Subject: Duke Energy Carolinas, LLC (Duke Energy)  
McGuire Nuclear Station, Units 1 and 2  
Docket Nos. 50-369 and 50-370

Response to Request for Additional Information Regarding License  
Amendment Related to Measurement Uncertainty Recapture Power  
Uprate (TAC Nos. ME8213 and ME8214)

RESPONSE TO REQUEST FOR ADDITIONAL INFORMATION BY THE OFFICE OF  
NUCLEAR REGULATION REGARDING A MCGUIRE LICENSE AMENDMENT TO SUPPORT  
A MEASUREMENT UNCERTAINTY RECAPTURE (MUR) POWER UPRATE

**Figure 1**  
 Regulatory Guide 1.99, Revision 2 Predicted Decrease in USE as a Function of Copper and Fluence for McGuire 1

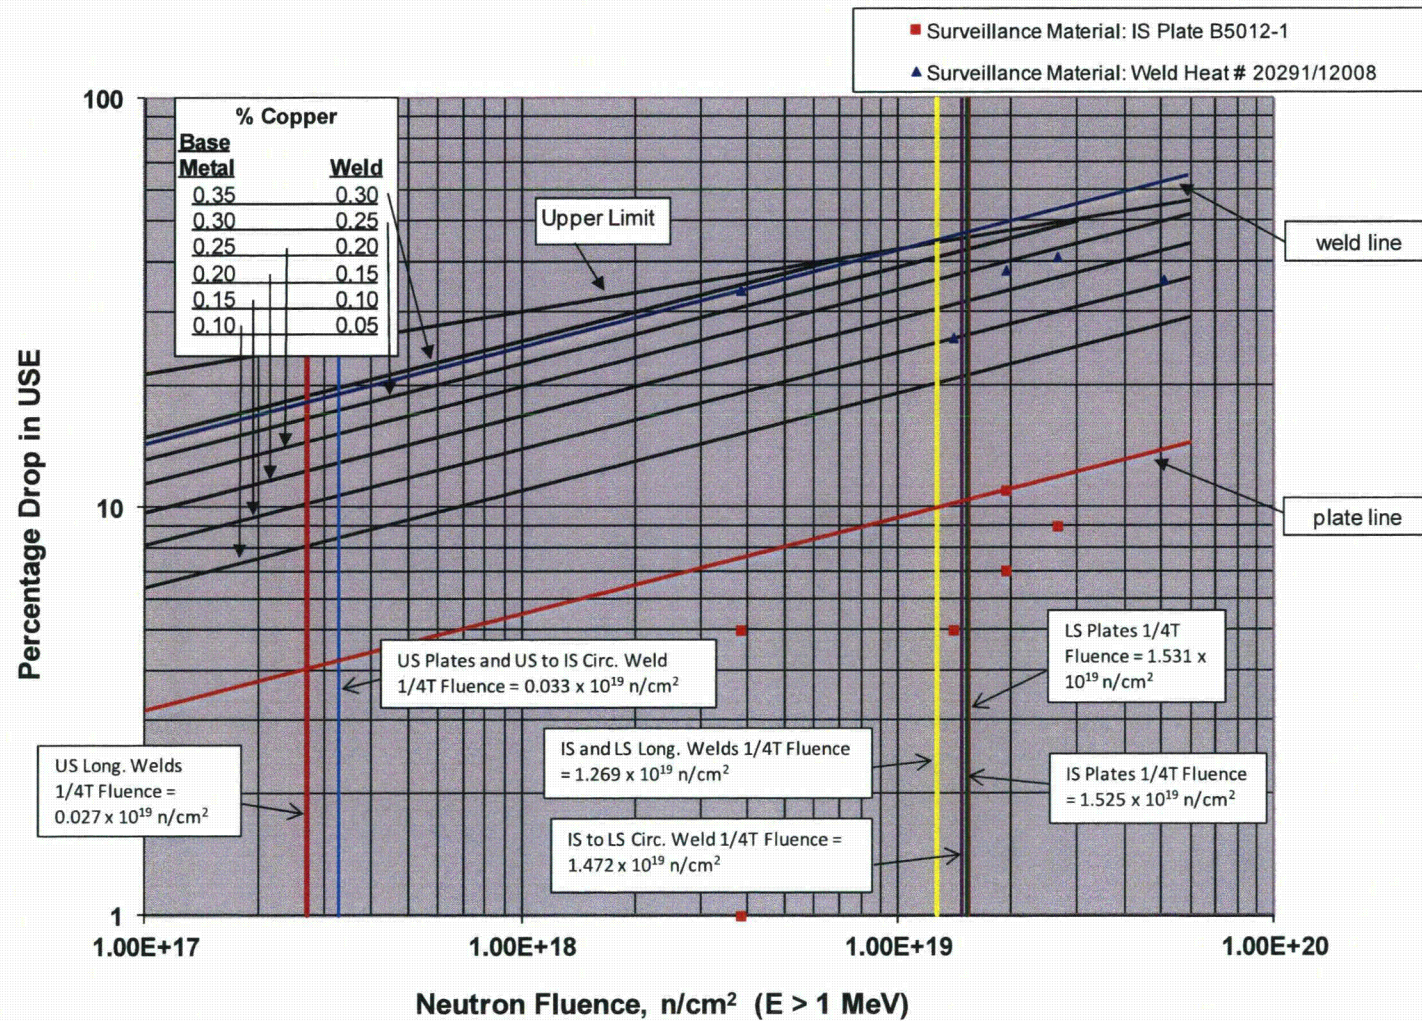
- The fluence at the  $\frac{1}{4} T$  location for the intermediate shell longitudinal welds 2-442A, 2-442B, and 2-442C of McGuire 1 decreased from  $1.63 \times 10^{19} \text{ n/cm}^2$  (LRLAR) to  $1.269 \times 10^{19} \text{ n/cm}^2$  (LAR) indicating that higher USE values should be expected for the LAR. Instead, the USE value decreased from 72 ft-lbs (LRLAR) to 60.5 ft-lbs. This appears to be caused by considering additional surveillance data. Please plot all surveillance data in Figure 2 of RG 1.99, Revision 2, to support the USE decrease that was used in estimating the LAR USE value for this material.*

**Response:**

The USE calculation for the intermediate shell longitudinal welds 2-442A, 2-442B, and 2-442C of McGuire 1 considered all reactor vessel surveillance data. The USE data was plotted on Figure 2 of Regulatory Guide 1.99, Revision 2 (Reference 7) and an upper bound line was drawn parallel to the existing lines on the Figure. See Figure 1 below. This new line was used to determine the percent USE decrease values at the  $\frac{1}{4}T$  fluence value of  $1.269 \times 10^{19} \text{ n/cm}^2$  for this weld material. The resulting USE percent decrease was higher (46%) than the values documented in the McGuire 1 LRLAR (36%), which resulted in the end of life extended (EOLE) USE dropping from 72 ft-lbs to 60.5 ft-lbs.
